风扇驱动电路1

LED电路

电池充电电路

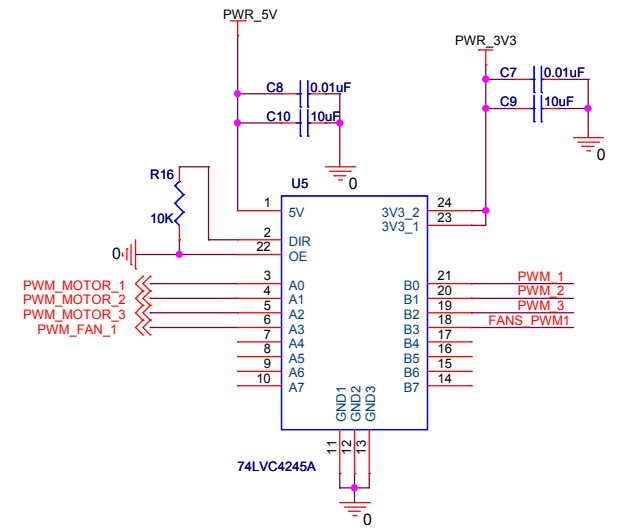
删除R19，R42

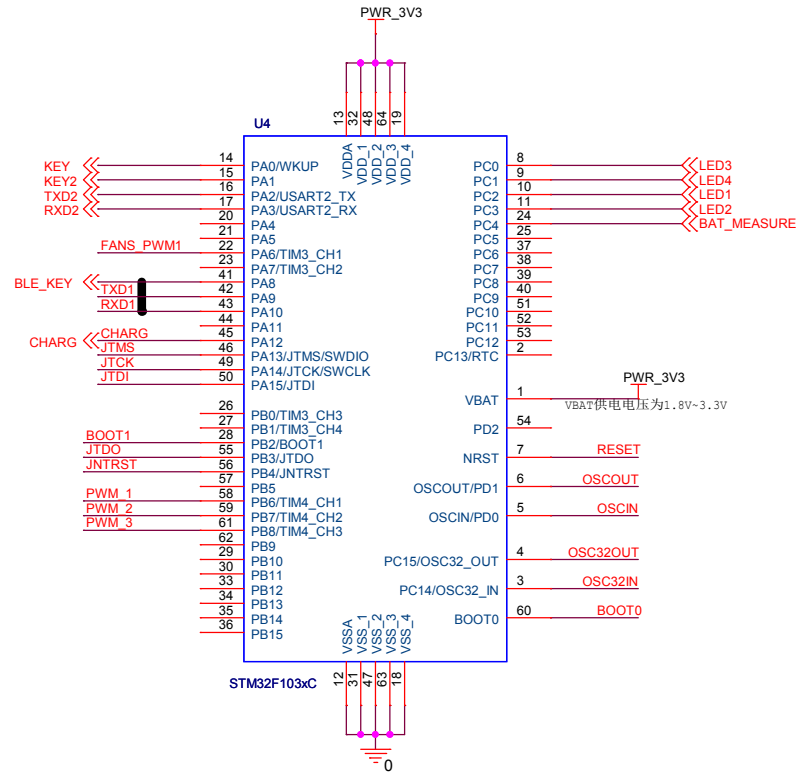
err: TX 与RX连反了

该接口必须是2.54mm间距
此处使用的是模块，注意封装大小

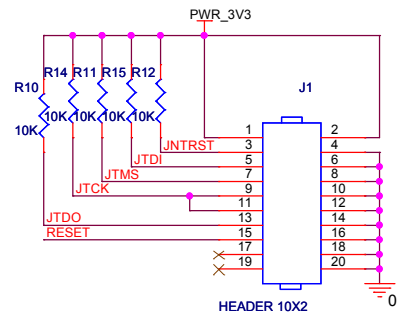
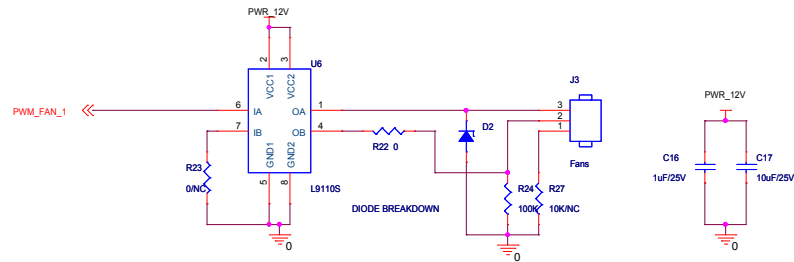
检查几个电阻的阻值是否太小?

此处管脚间距需要重新定一下，需要和机器一致，直接插即可
